ADDENDUM #1

Date of Addendum: JAN 7, 2021

UWMC 7NE Nursing Unit Upgrade UW Project No. 207310

Prepared by Buffalo Design Architecture | Interiors

6 ice machine cabinet section
SCALE: 1" = 1'-0" alternate 3

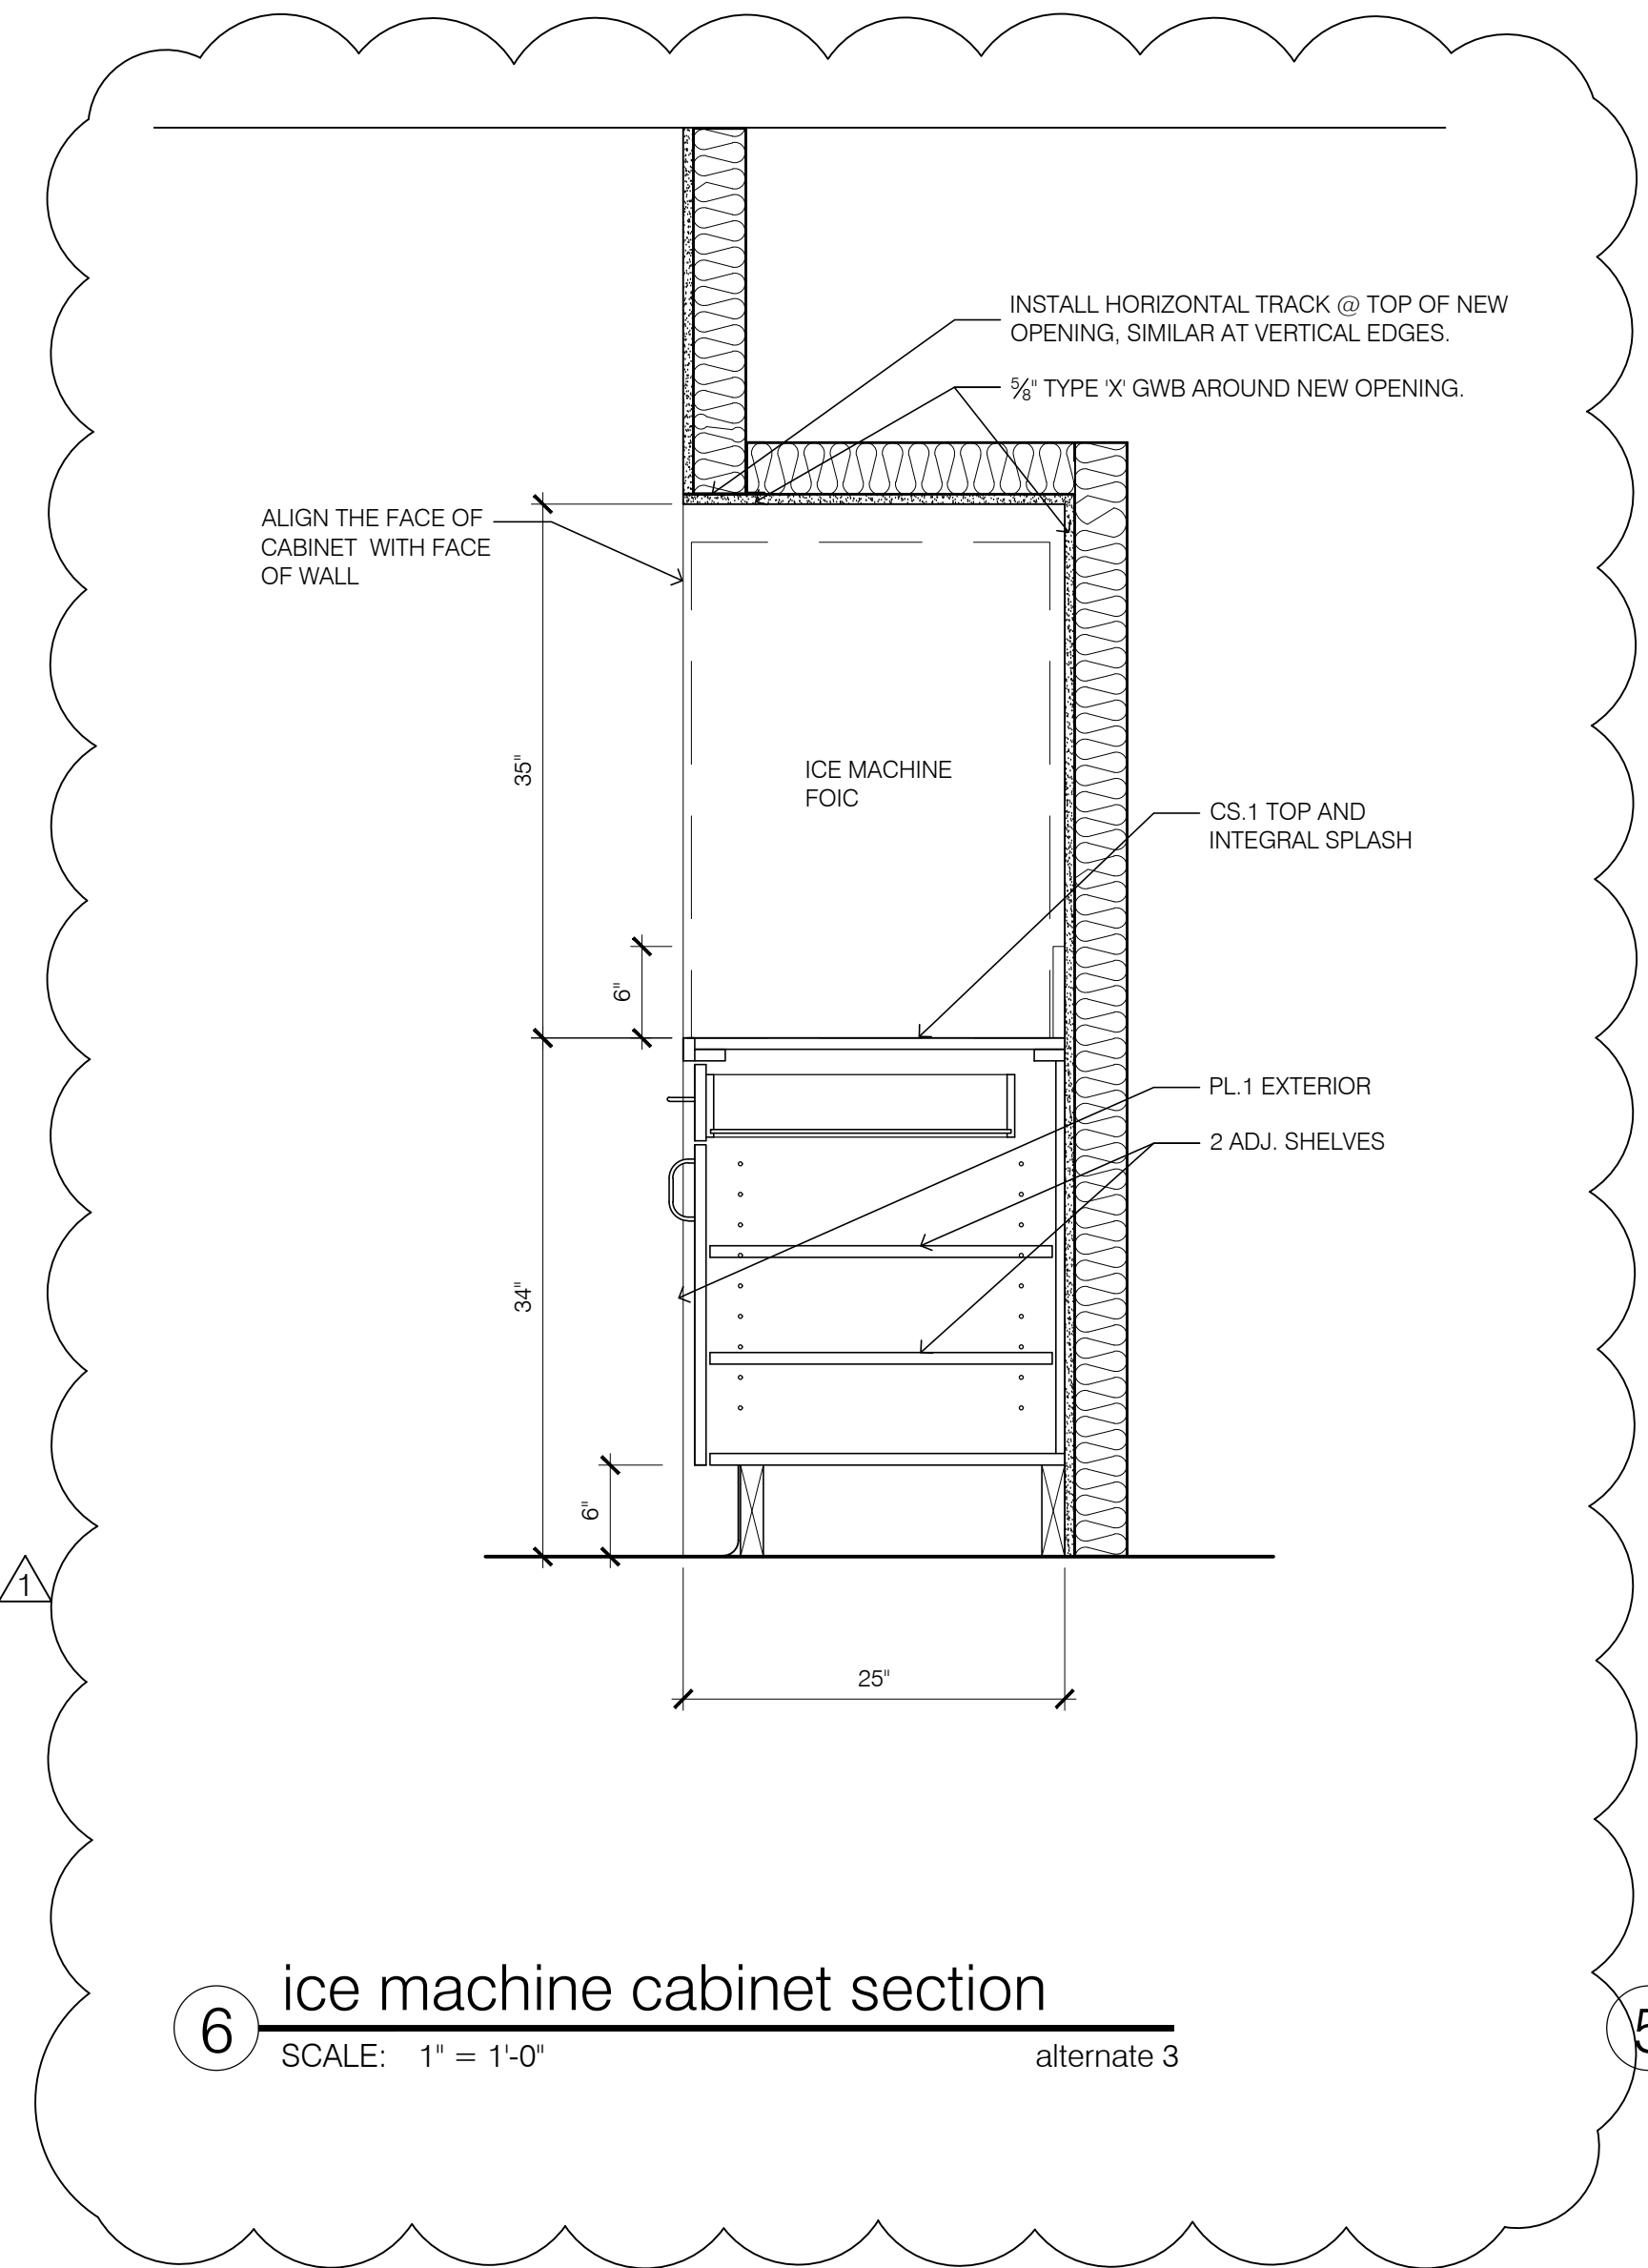
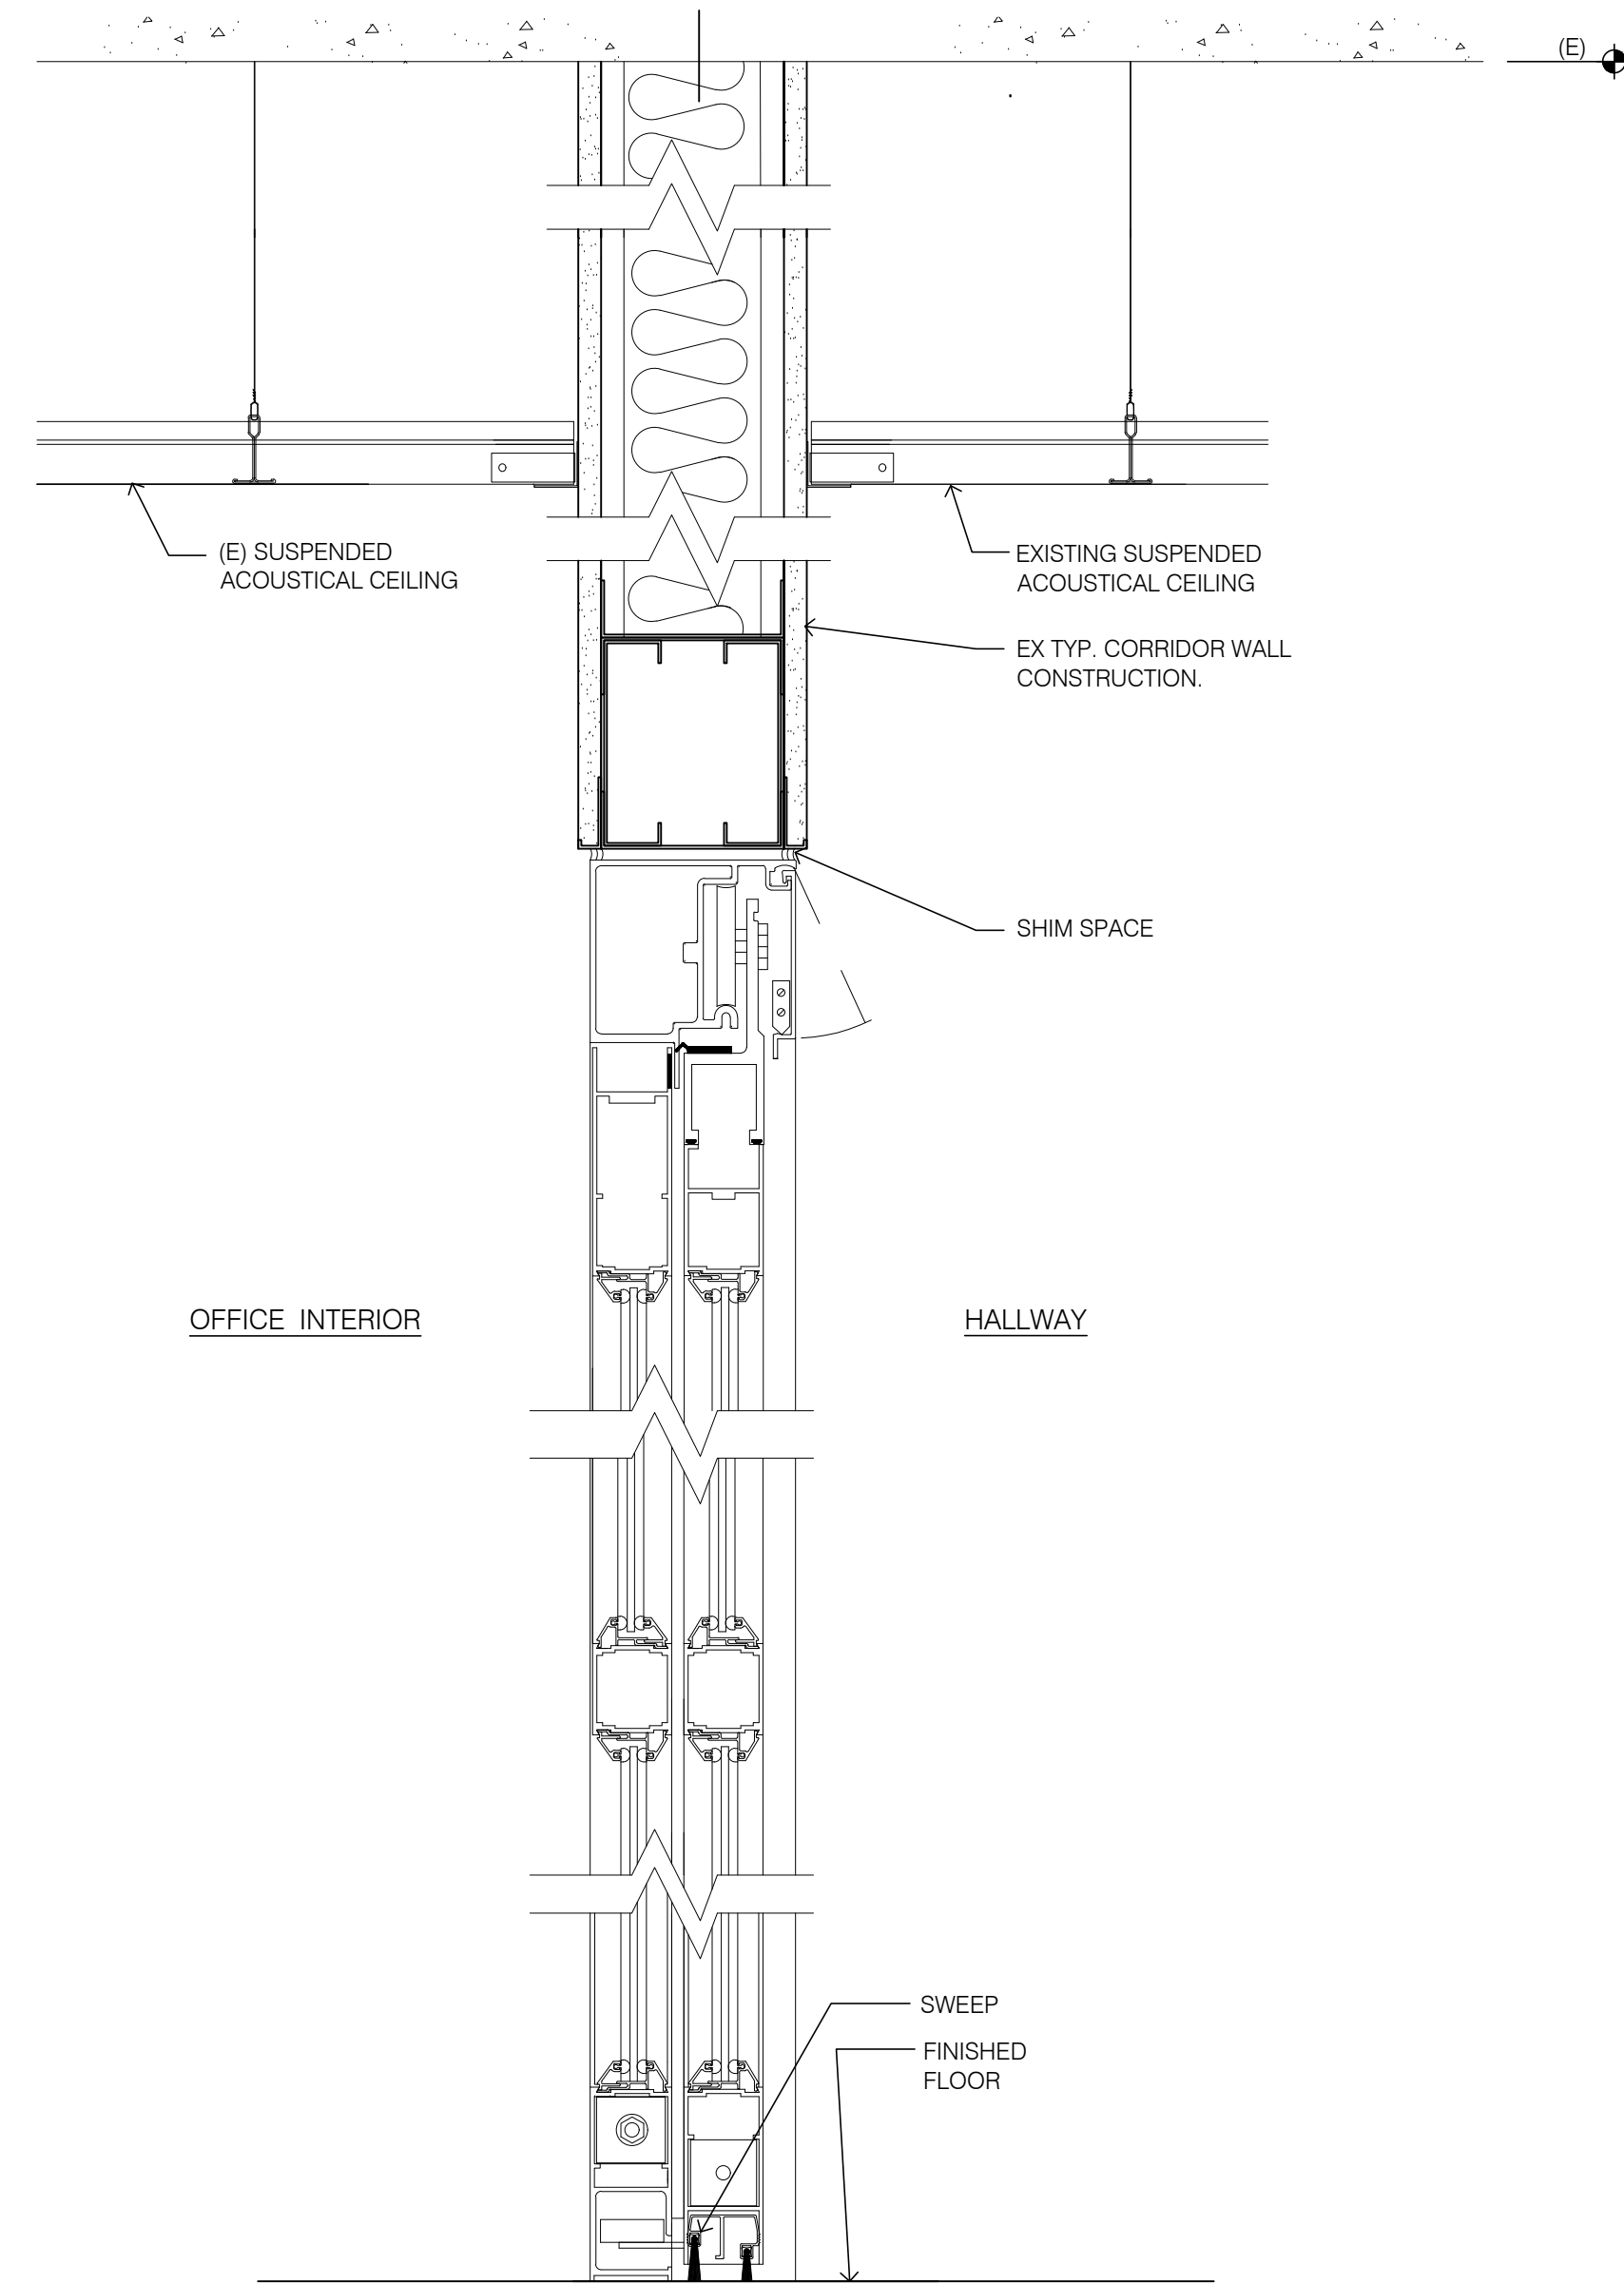
| Item | Drawing No. | Description of Change |
|------|-------------|--|
| 4.5 | a502 | Revise Detail 6 as shown on the attached Sheet. |
